Northgate Pedestrian Bridge

This was the SDC's third review of the concept design phase for the Northgate Pedestrian Bridge. The purpose of this meeting was to review the concept design phase, which has undergone significant design changes since the SDC's previous review in September 2015. After the presentation and discussion, the SDC voted 6-2, to approve the concept design phase for the Northgate Pedestrian Bridge with several recommendations.

May 18, 2017

Schematic Design

Figure 2. Proposed alignment and slope modification

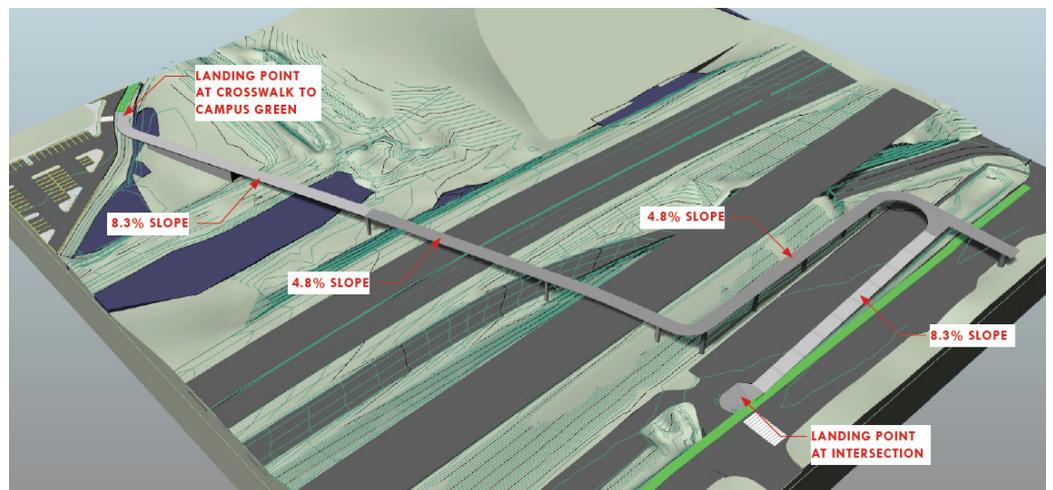
The SDC is very concerned with the proposed 8.3% slope on the west and east approach. Commissioners agreed the proposed slope, while at the legal maximum, would limit accessibility and highly recommended the design team provide strategies for reducing the slope percentage.

Ben de Rubertis - Overall, this is an impressive effort to redesign a bridge to meet a much smaller budget. But, I have not seen a precedent where using 8.3% slopes allows a bridge to function well. I would have chosen to make a condition to design the bridge at a slope of 5%, at least on the west approach. I think all users will benefit from the continued study of reducing the slope.
